BID ADDENDUM NO. 1
TO
CONTRACT DOCUMENTS
AND
TECHNICAL SPECIFICATIONS
FOR
POOL LOCKER ROOM RENOVATIONS
AT
HOMMOCKS MIDDLE SCHOOL
NYSED #66-07-01-03-0-011-031

Mamaroneck Union Free School District
1000 West Boston Post Road
Mamaroneck, NY 10543

LAN Job #4.1092.87
September 13, 2024

DOOR SCHEDULE & PARTITIONS
POOL LOCKER ROOM RENOVATIONS AT
HOMMOCKS MIDDLE SCHOOL
130 HOMMOCKS ROAD
LARCHMONT, NY 10538

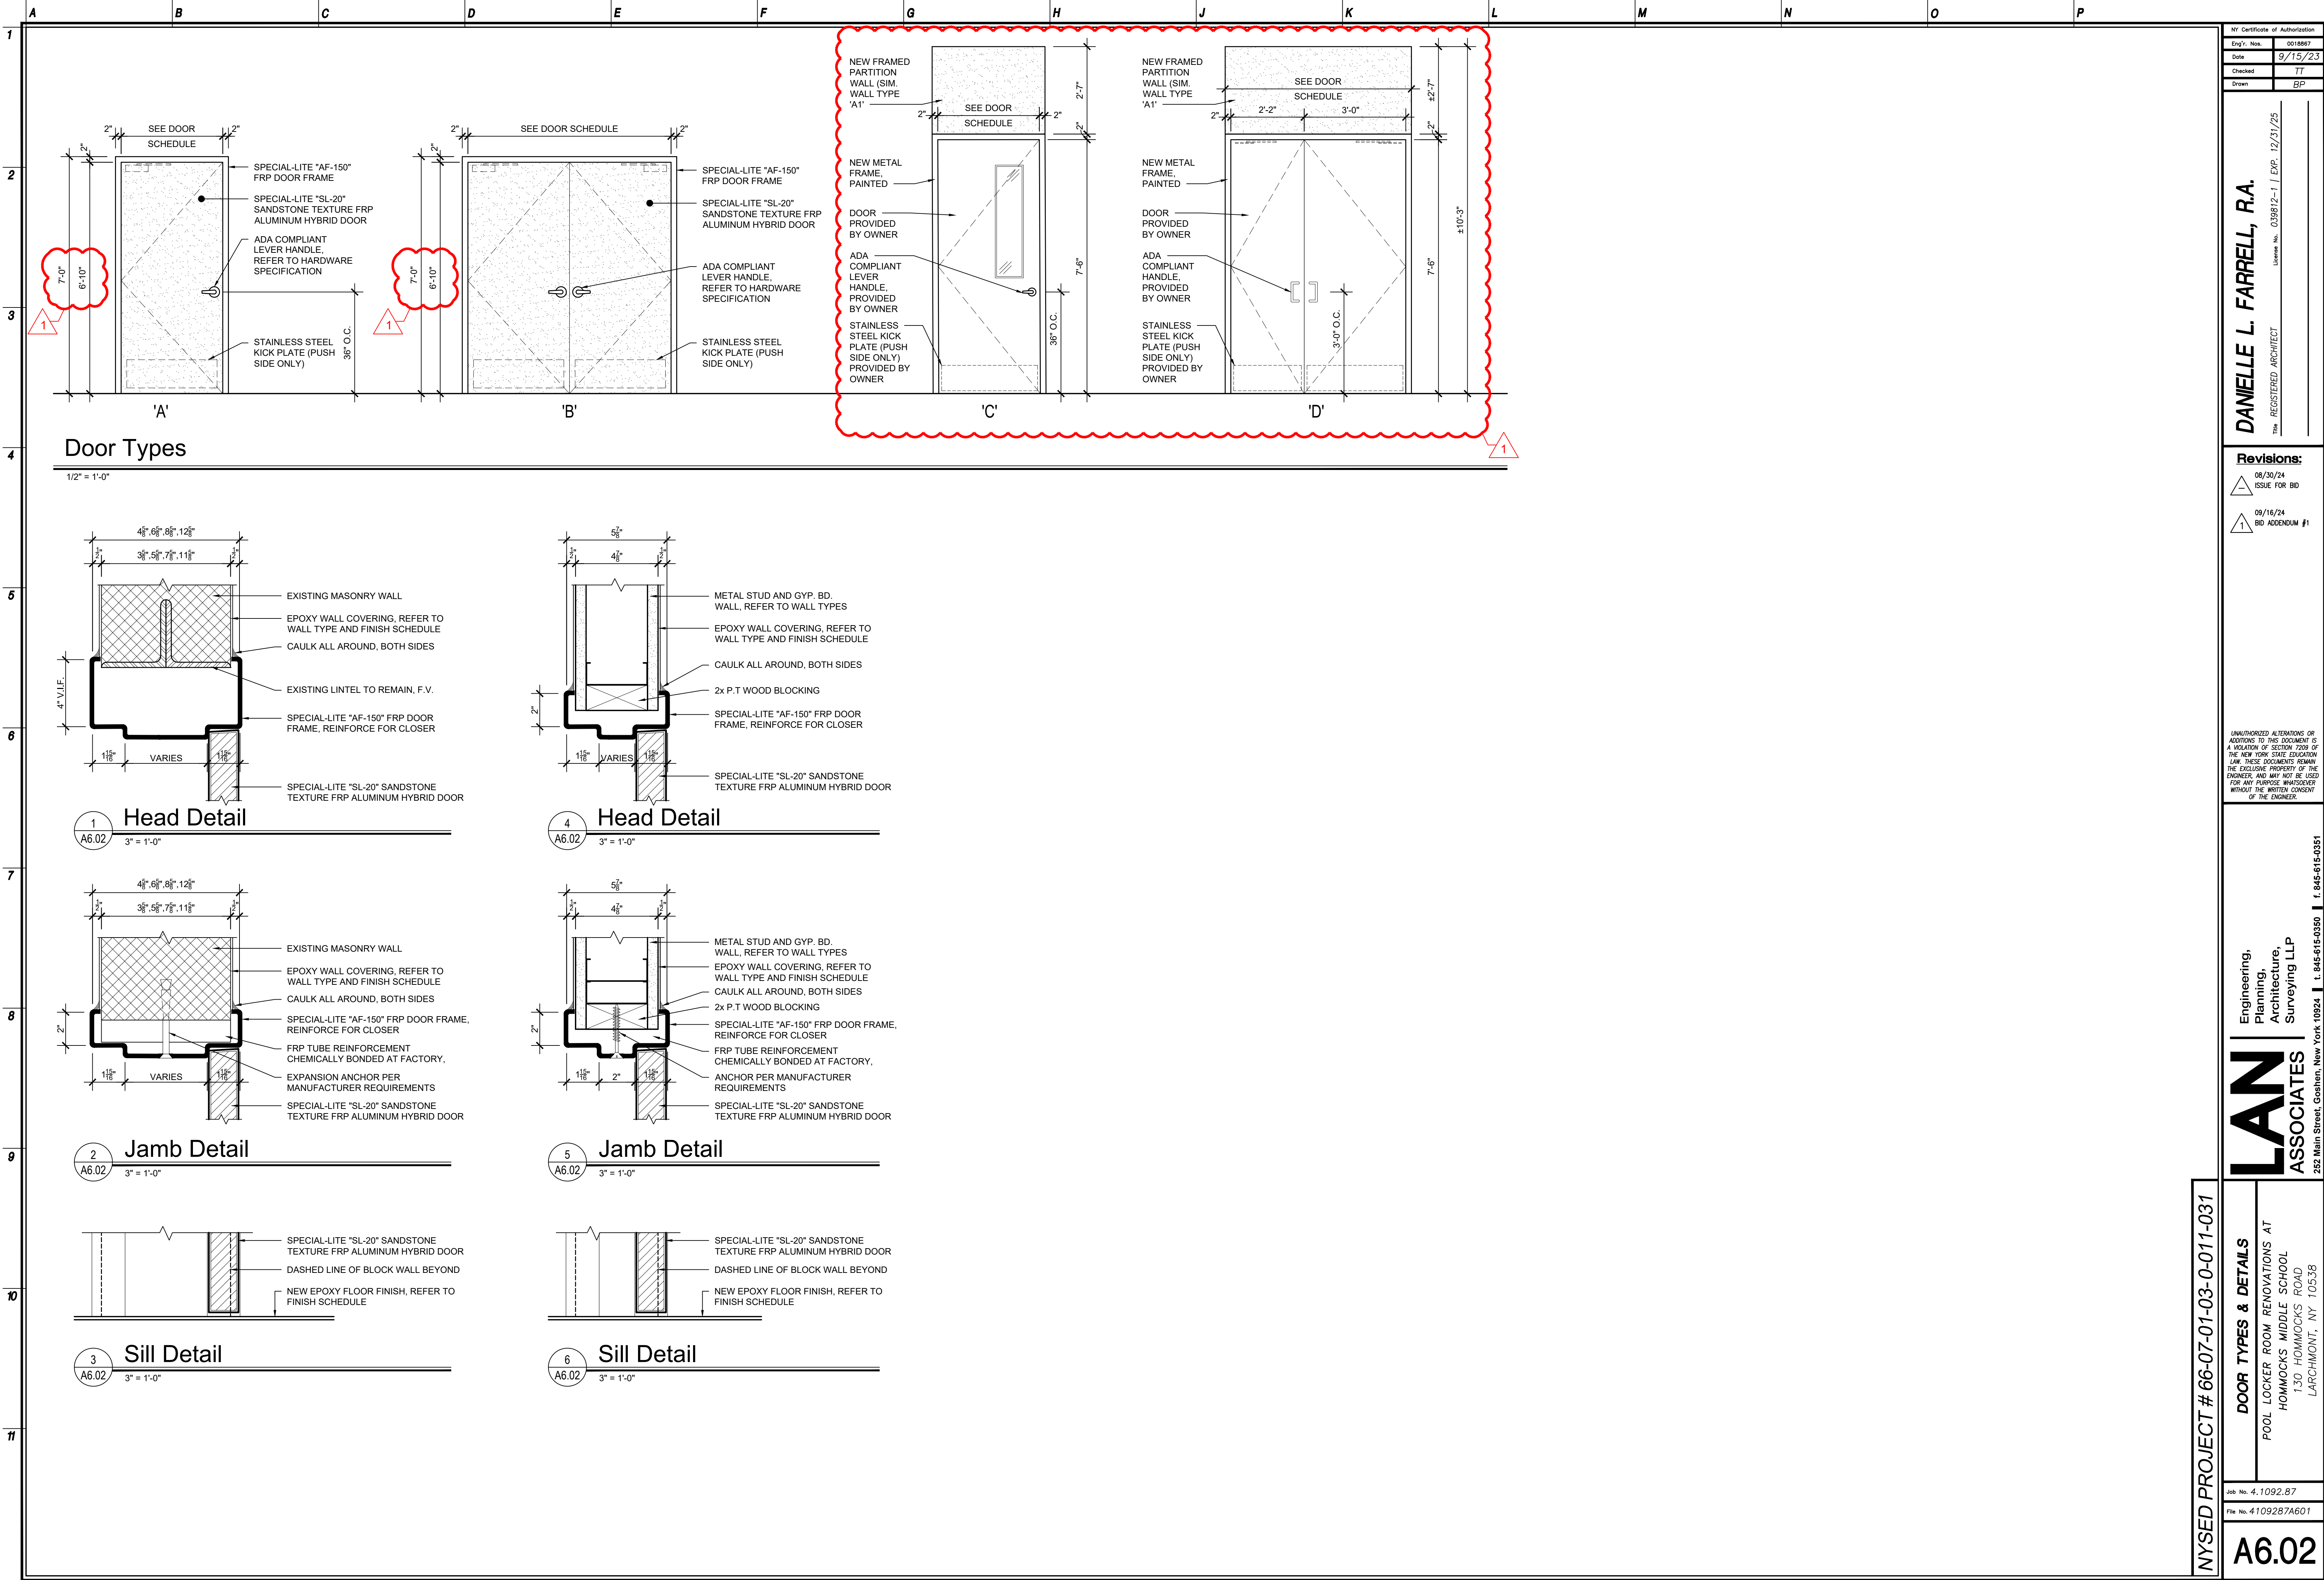
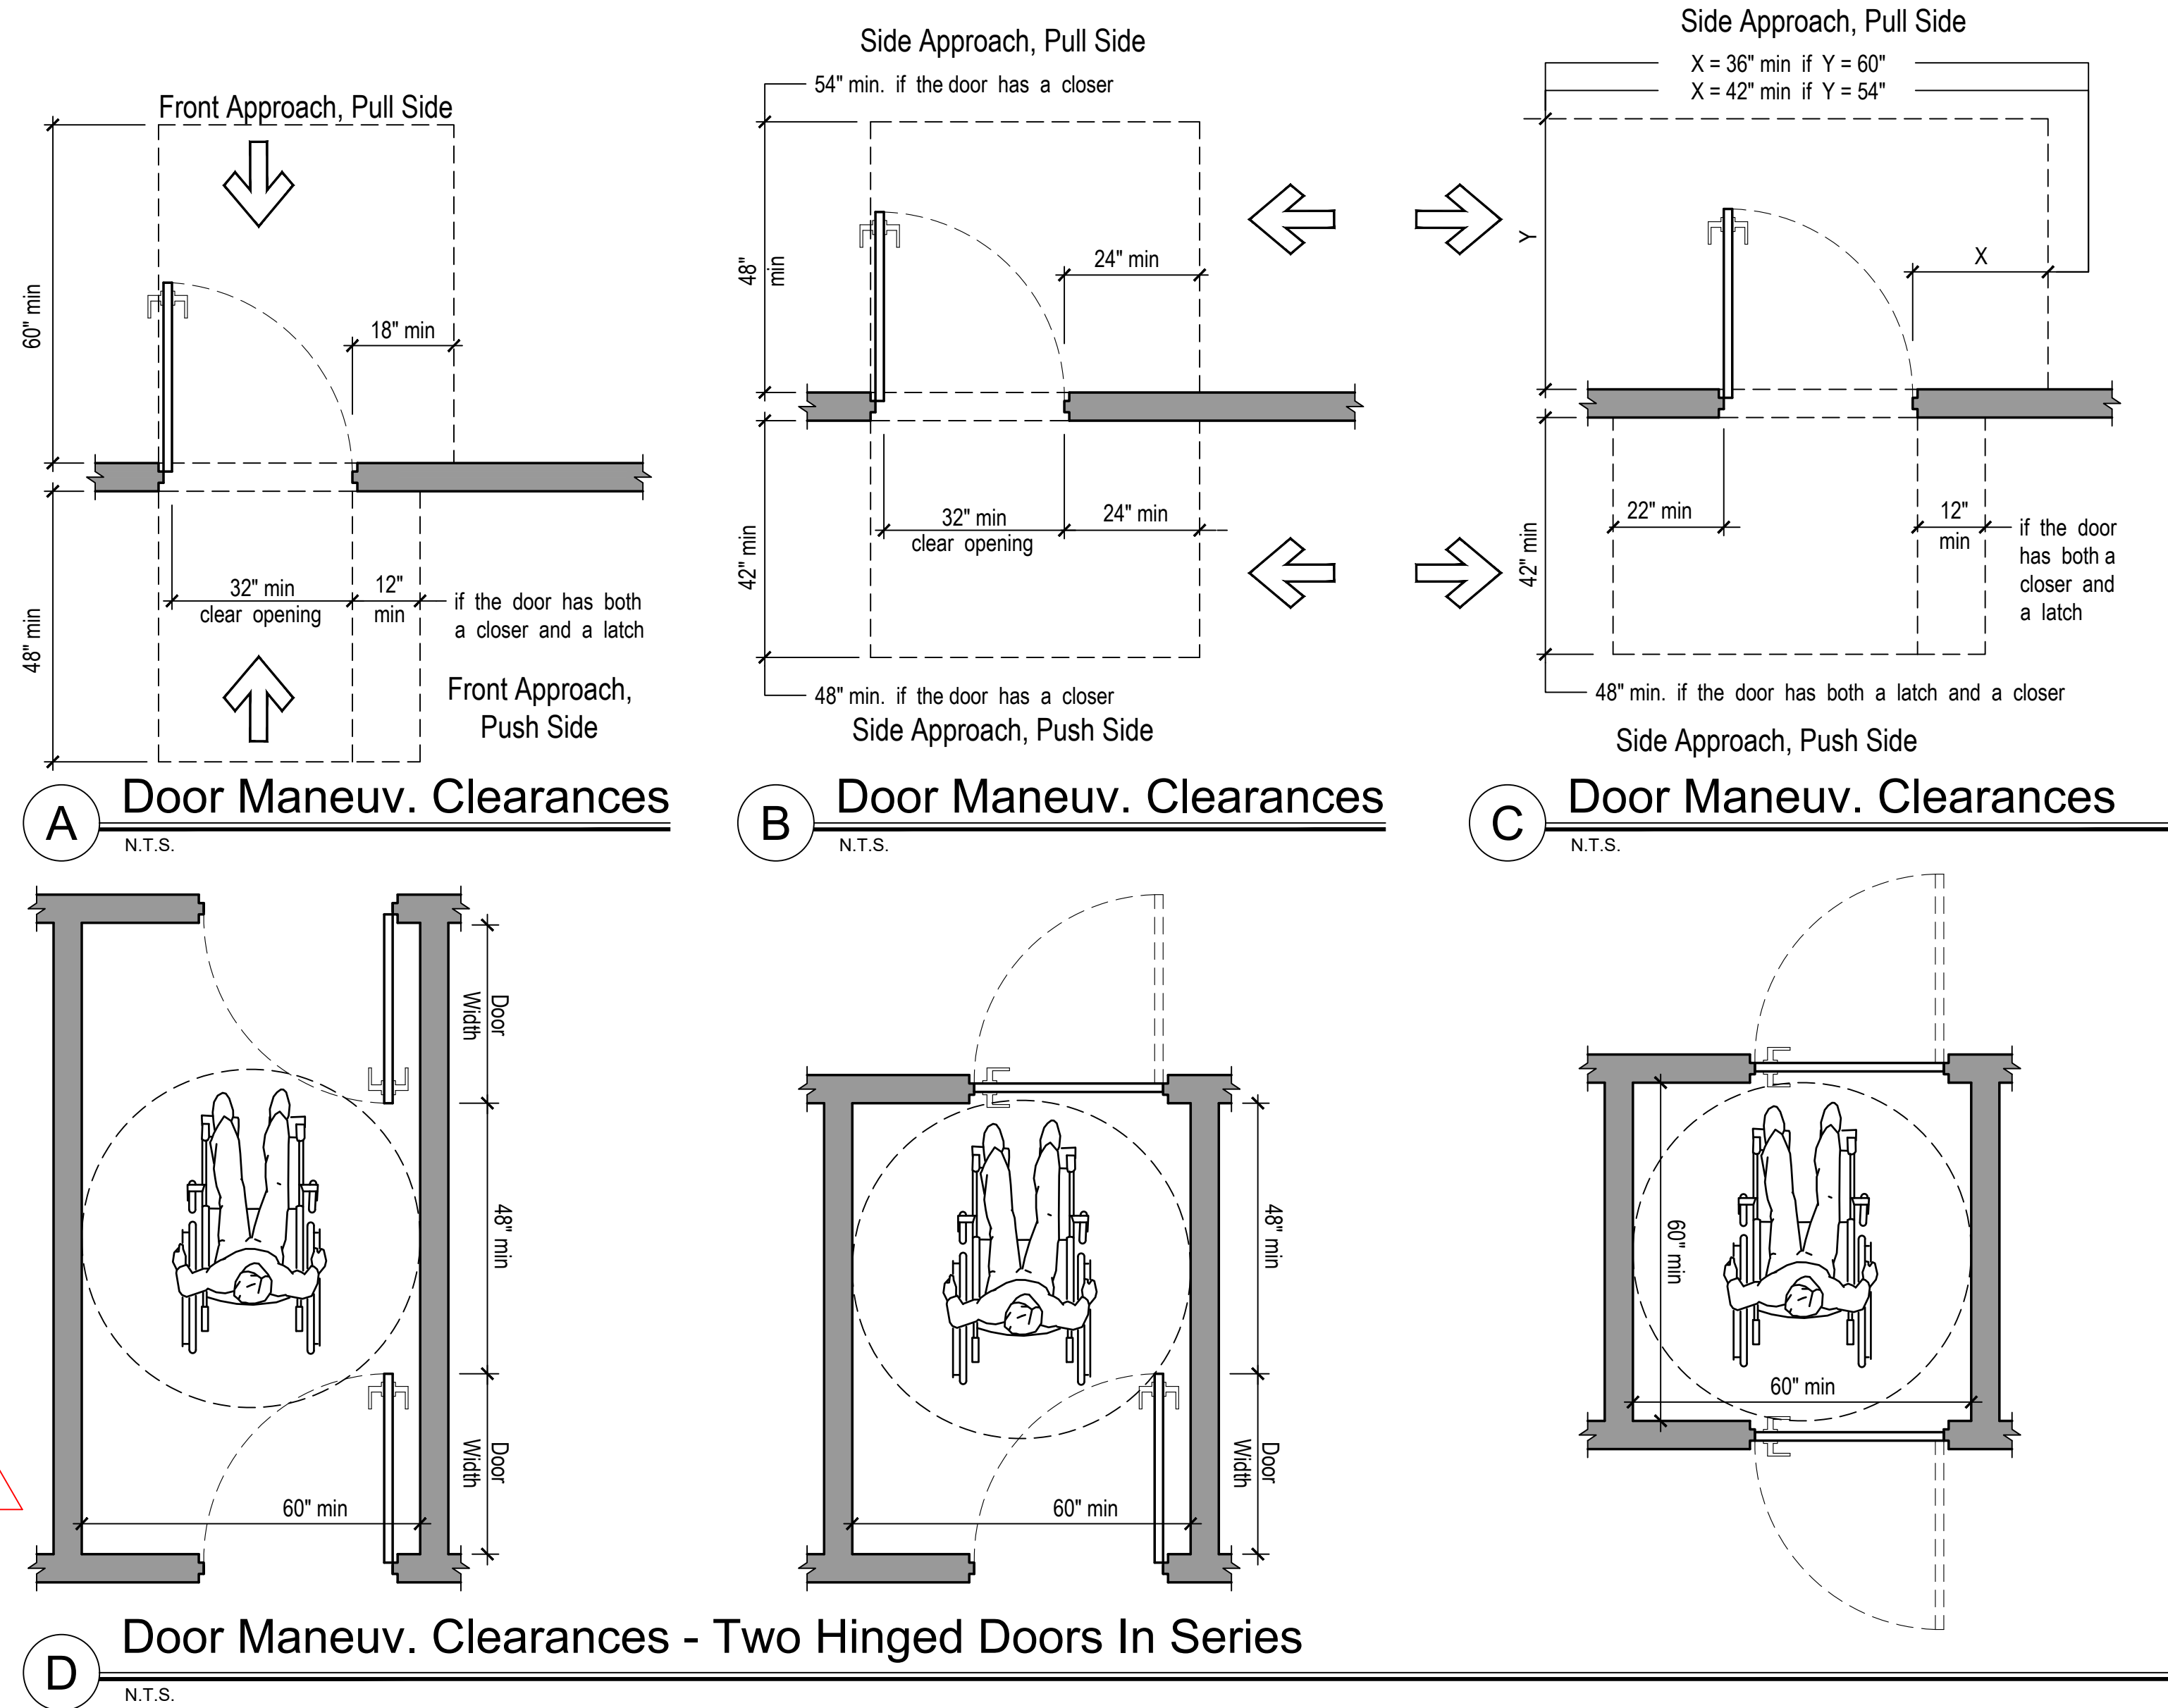
19	<p>Comment: The GC bid form has alternate 5 as having four doors. The door schedule shows eight doors. Please advise.</p> <p>Response: Drawing A2.02 has been revised to include doors D06, D07, D08, and D09.</p>
20	<p>Comment: Swimming pool tile grout cannot be removed w/o damaging the tile. Please confirm the existing swimming pool grout can be power washed to remove any loose grout. New epoxy grout can be skim coated on top of existing pool.</p> <p>Response: Refer to Pool Power Washing note on drawing A1.03.</p>
21	<p>Comment: Please confirm Spectralock epoxy grout by Laticrete is acceptable in lieu of the specified SGM.</p> <p>Response: If a substitution is being requested, please follow the instructions in the documents for substitution request and provide a side-by-side comparison of your proposed substitution and verify that it meets or exceeds the basis of design to the specified product.</p>
